Technical Service Note 32-09

SUBJECT: Airliner Forward HD 6-Piece Bolted Crossmember Gusset Replacement.

PRODUCTS: Cascadia vehicles equipped with an Airliner rear suspension and the HD 6-piece bolted style forward suspension crossmember.

Illustration 1

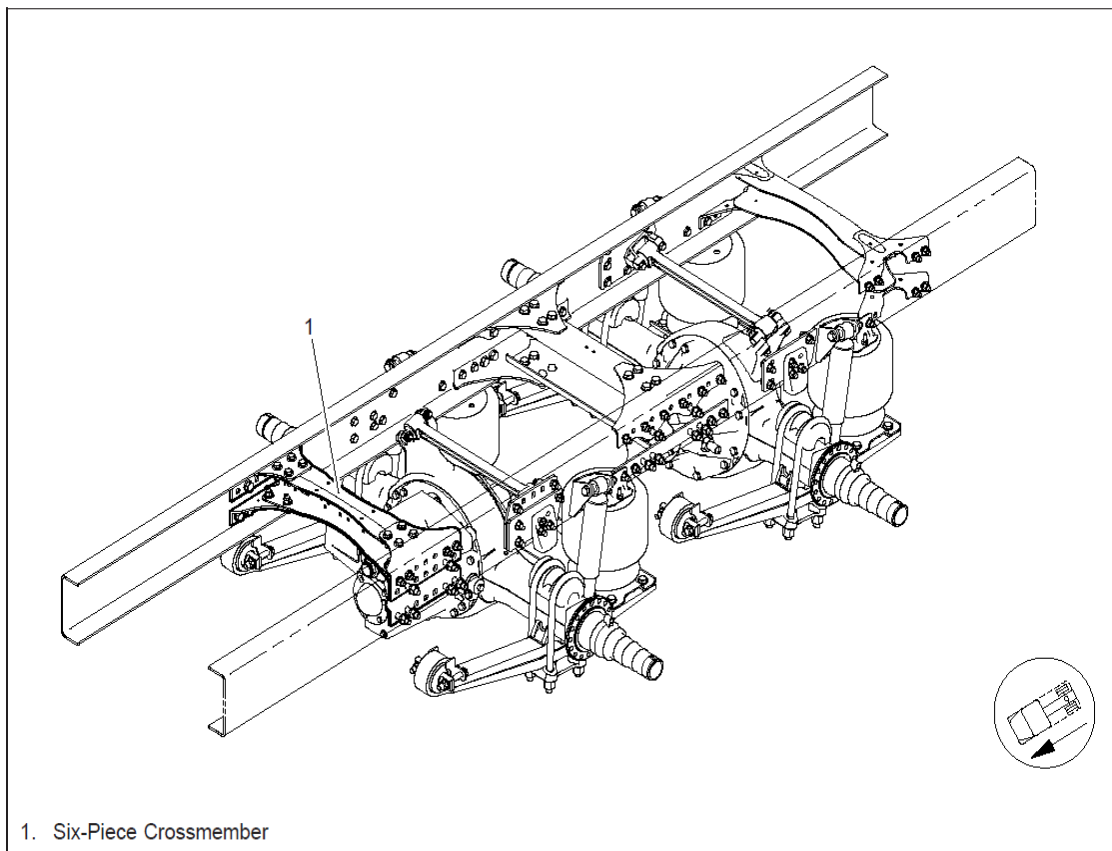
PROBLEM / SYMPTOMS: In certain tanker applications the upper gussets on the HD 6-piece bolted style crossmember has cracked.

The upper and lower gussets will be replaced with improved (80KSI) P/Ns. A reinforcement plate will also be added to the upper gussets.
Reference illustrations 1 & 2

Photo 3

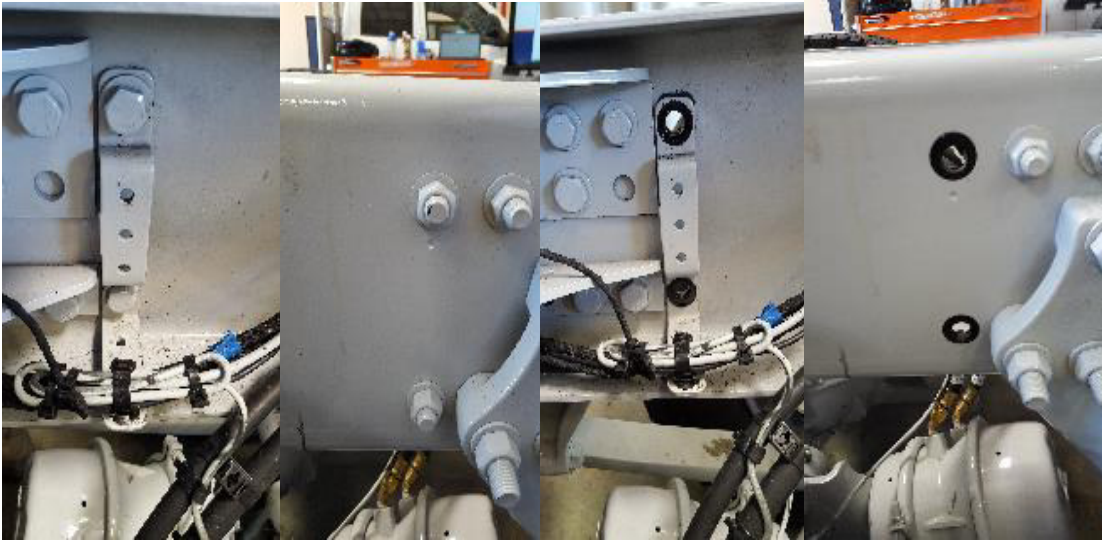
- Remove the two airline routing bracket bolts and leave bracket in frame and connected to air lines. Ref. Photo 3

Photo 4

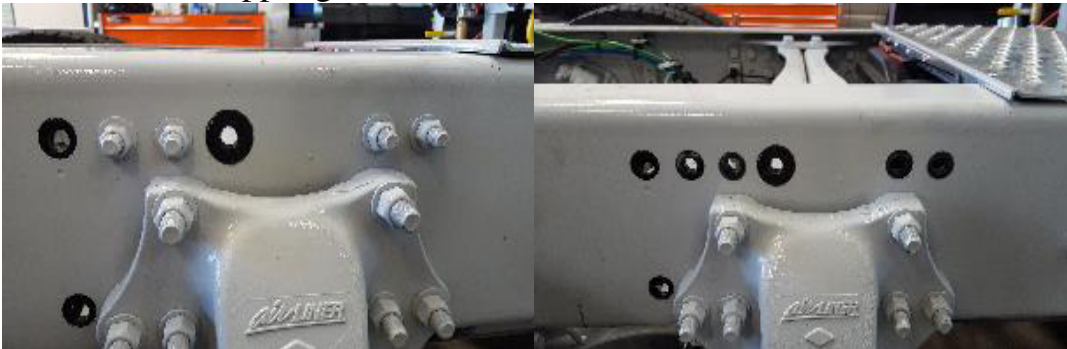
- Remove four upper gusset to frame bolts. Ref. Photo 4
